RESPONSE SUMMARY FOR COMMENTS ON OPERABLE UNIT NUMBER 11 FIELD
SAMPLING PLAN TECHNICAL MEMORANDUM - WSB-054-94

This letter transmits 1 copy of the enclosed Technical Memorandum, Revised Field Sampling
Plan for Operable Unit 11

CDH Comments

**OUTLINES-168 Resemap
West Spray Field
Proposed Monitoring Well
Locations
Figure 4-2**

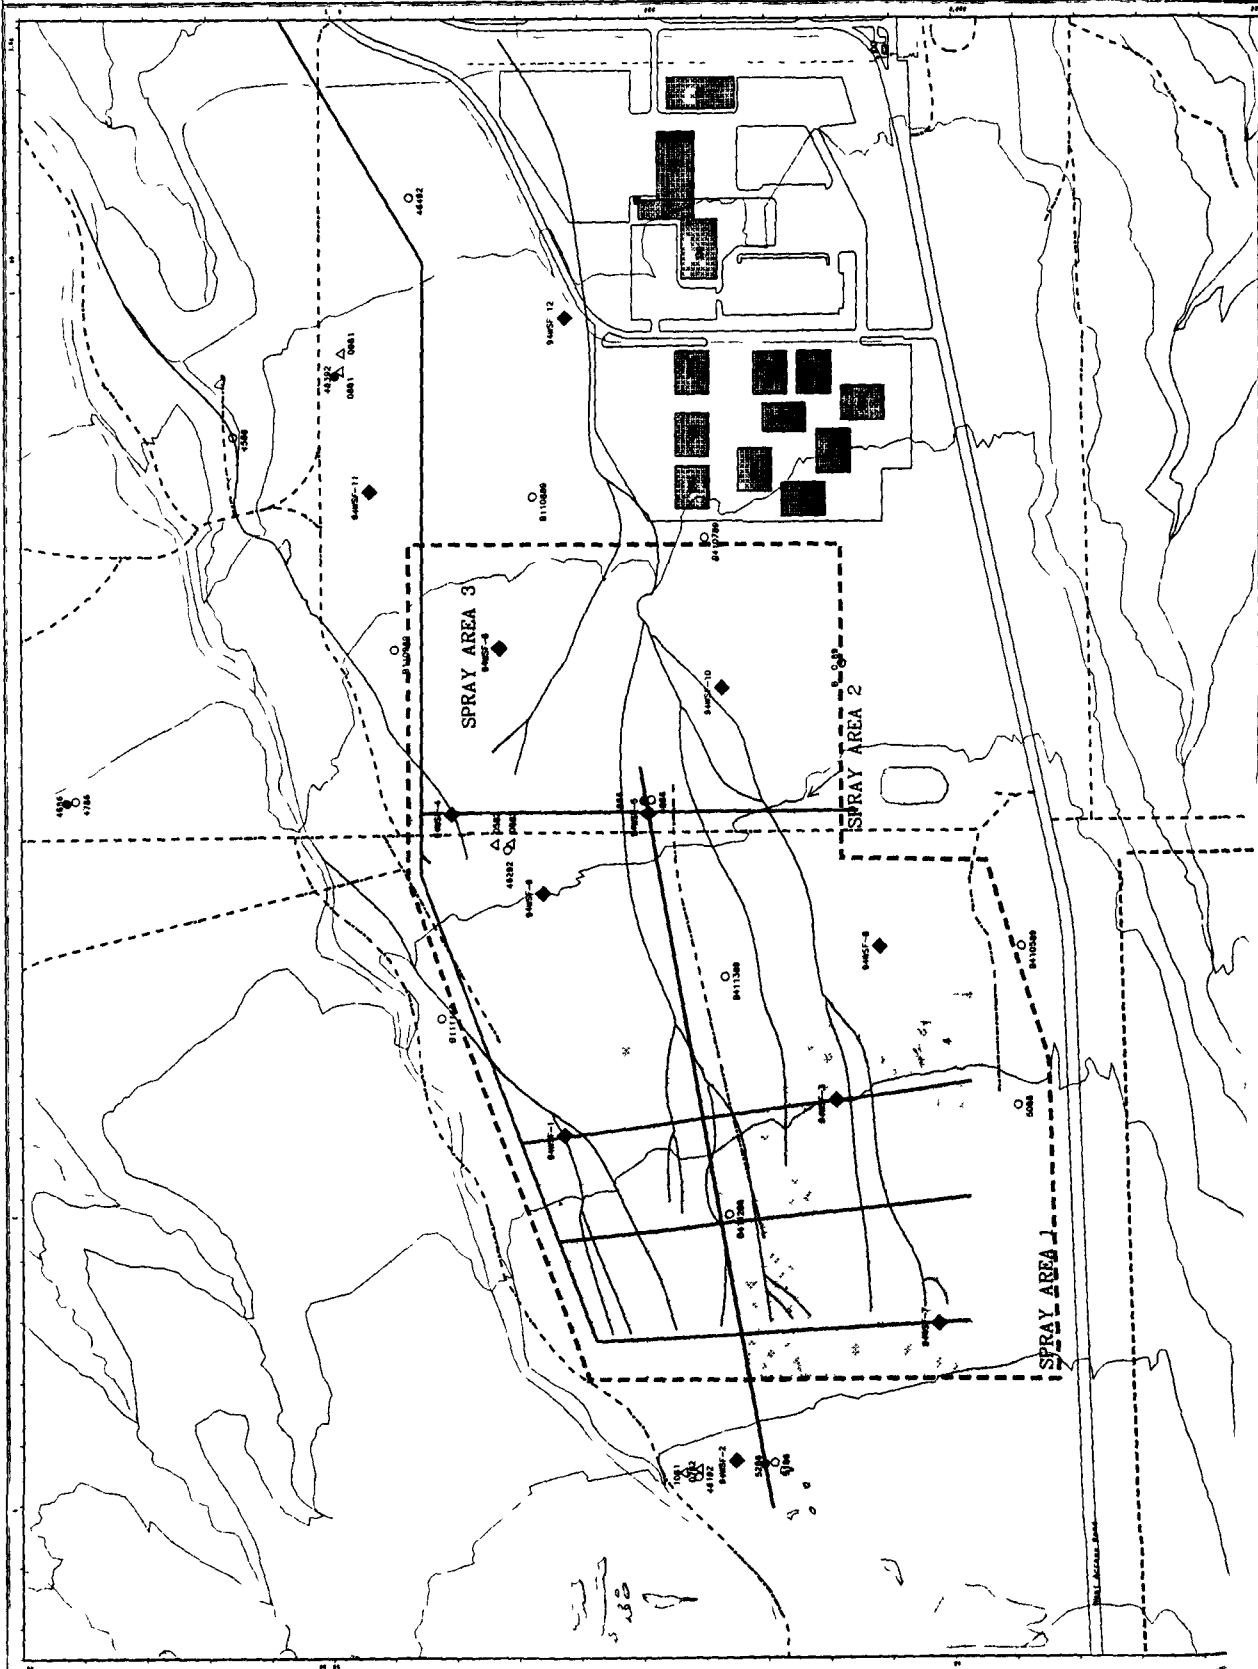
- 2 An additional four boreholes and monitoring wells have been proposed in the FSP (reference attached map). As mentioned in bullets above, one of the goals of characterizing the vadose zone is to determine if perched water zones larger than 1000' are present under the WSF (please see CDH General Comment Number 3). Placement of the new monitoring wells will also assist in vadose zone characterization and more extensive monitoring of the saturated zone as the wells will be completed there if perched water can't be found.

- 3 The addition of four more boreholes and monitoring wells should adequately address this comment.
- 4
 - See the attached map of new monitoring well locations. The combination of additional and existing wells provides five wells downgradient from Spray Area 1, 3 downgradient from Spray Area 2, and 2 downgradient from Spray Area 3.

- 7 This was an error. Text describing the locations of the boreholes and monitoring well location has been changed to reflect corrections, new logic, and four new locations:

- WSF-1 • Provides northwest area coverage
 - Located beneath historical pipeline location
- WSF-2 • Near well 5186, where elevated nitrate concentrations have been recorded
 - On seismic line
- WSF-3 • Fills in area of insufficient data
 - On historical pipeline location
- WSF-4 • Provides coverage of northernmost area of Spray Area 2
- WSF-5 • Near well #4986, where the highest level of nitrate/nitrite was recorded
 - On the seismic line
- WSF-6 • Centrally located in Spray Area 3, where there is a lack of data
- WSF-7 • Provides coverage of the southwest corner of OU 11
 - On historical pipe location
- WSF-8 • Provides coverage in the south central portion of the WSF
- WSF-9 • Fills in data gap in the direction of groundwater flow from Spray Area 1
- WSF-10 • Provides coverage in the southeast area of the WSF

Figure 4-1

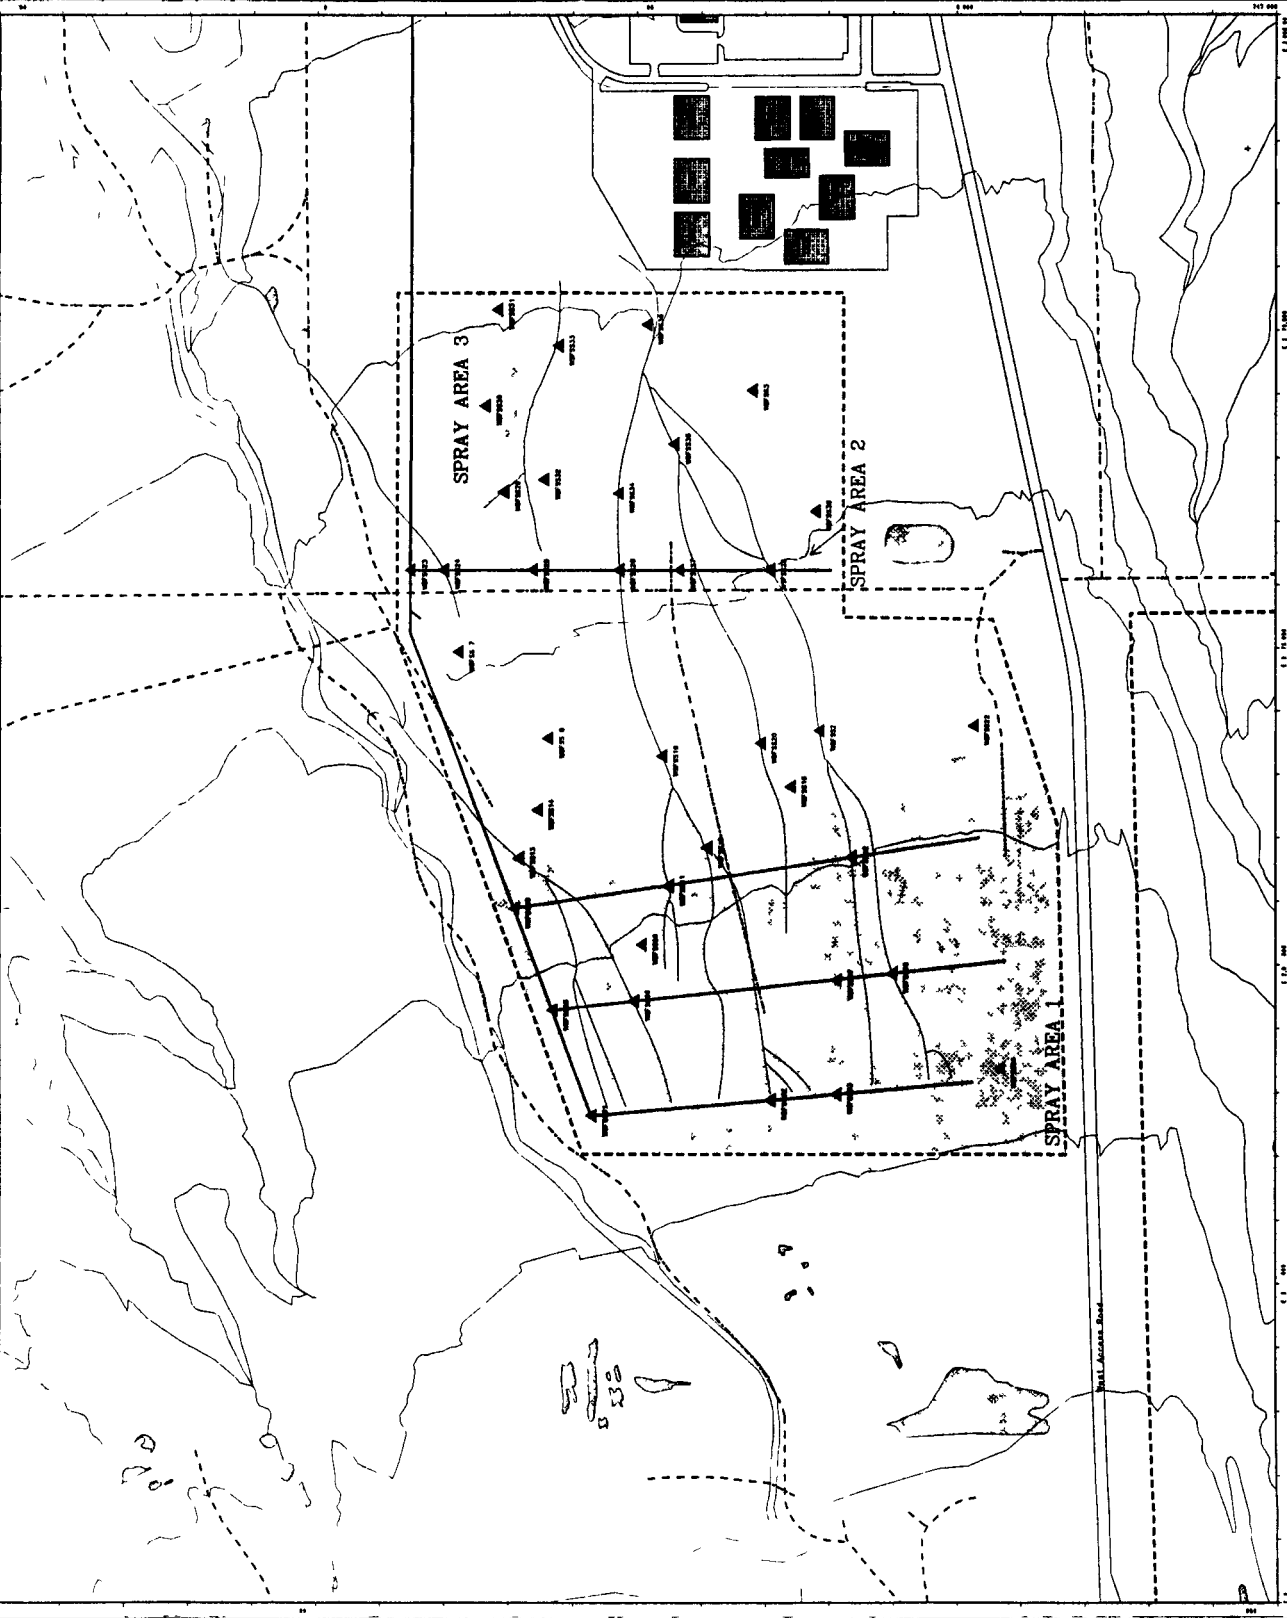
6th paragraph Four new surface soil sampling locations have been added at locations of pipe junctures as those are the most likely areas at which hot spots may be found The revised map is attached
